MIDLAND PROJECT  
QUALITY ASSURANCE  
DEPARTMENT

NONCONFORMANCE REPORT

C-03736 SU

(Door #23, WATER TIGHT) WELDS

## ATTACHMENT #1

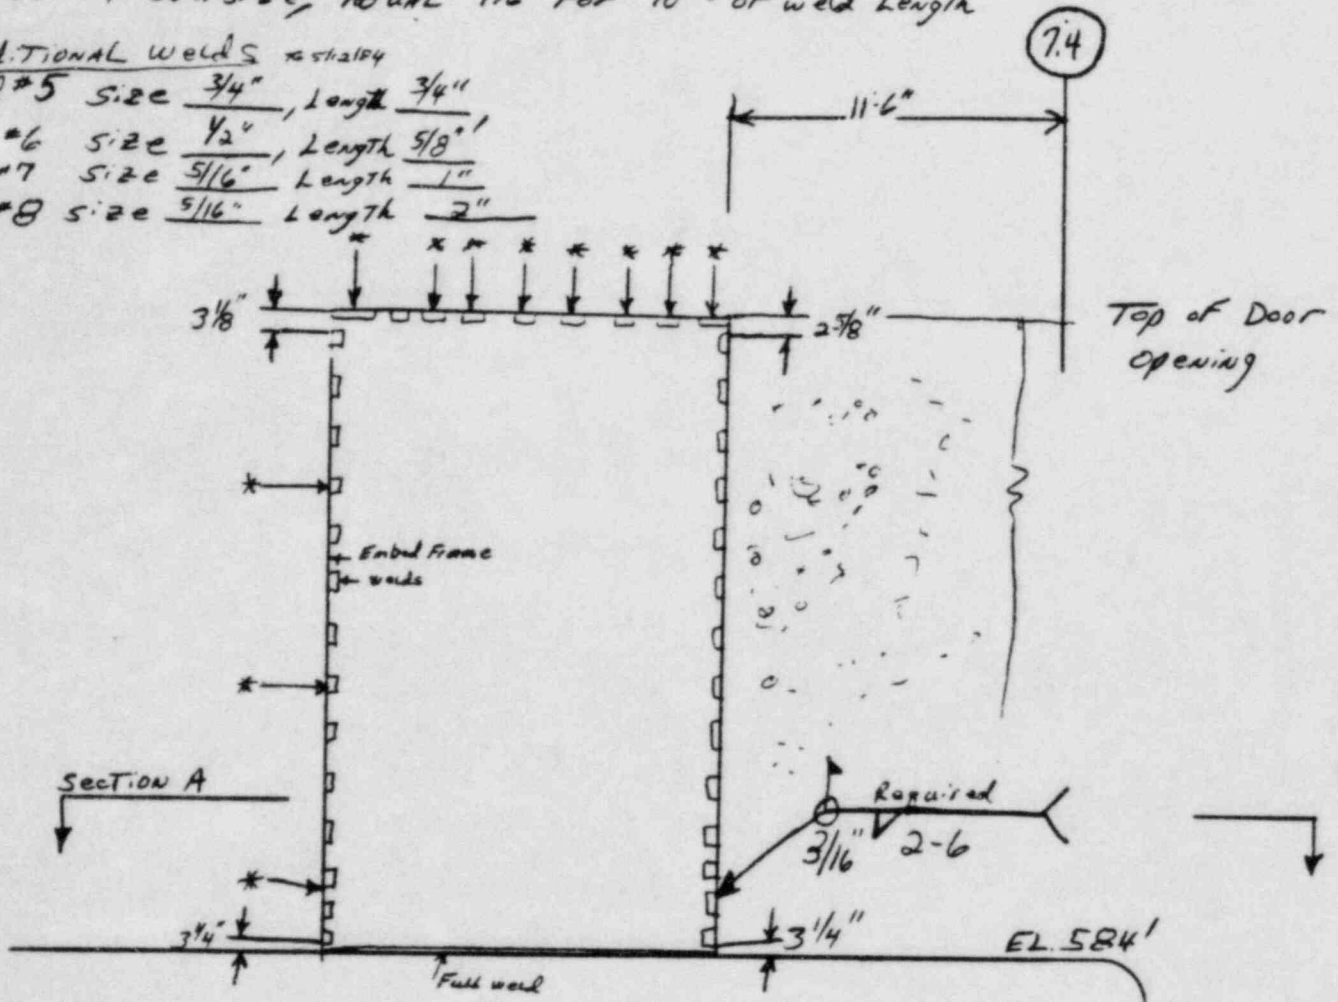
(4) The intermittent Fillet welds ( $3/16"$  - 2" Long + 6" Pitch) connecting Door Frame To Embedded Angle DOES NOT HAVE INCREMENTS AT THE ENDS. See ATTACHMENT #1. This <sup>APPLIES</sup> ~~APPLIES~~ TO THE VERTICAL ENDS OF THE FRAME ONLY.

(5) The welds identified with a \* symbol ON ATTACHMENT 1 ARE THOSE WITH WELD SIZES IN EXCESS OF  $+3/16"$ . THE AVG. ACTUAL SIZE IS  $7/16"$  FOR ENTIRE WELD. WELDS #3 oversize AND #4. (See ATTACH 1)

(6) ADDITIONAL WELDS INDICATED ON ATTACHED SKETCH SECTION "A-A" <sup>ARE</sup> ~~NOT~~ SHOWN ON DRAWINGS.

NOTE:  $1/4"$  ground OFF OF WELD #7 (Length), These welds <sup>CONNECT</sup> ~~WALL~~ Embedded Angle Frame To Embedded Floor Angle Frame.

- ① The symbol \* indicates (Oversize welds, #1) to shop
- ② Weld #3 oversize, ACTUAL  $7/16"$  For 10% of weld Length  
Weld #4 oversize, ACTUAL  $7/16"$  For 10% of weld Length

- ③ Weld #5 size  $3/4"$ , Length  $3/4"$   
Weld #6 size  $1/2"$ , Length  $5/8"$   
Weld #7 size  $5/16"$ , Length  $1"$   
Weld #8 size  $5/16"$ , Length  $2"$

Section A

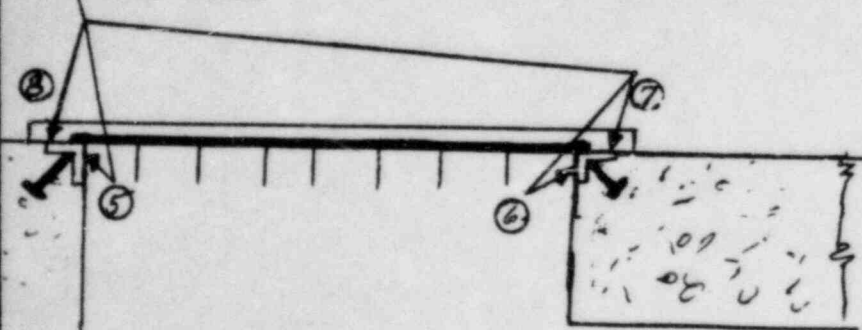
Additional welds
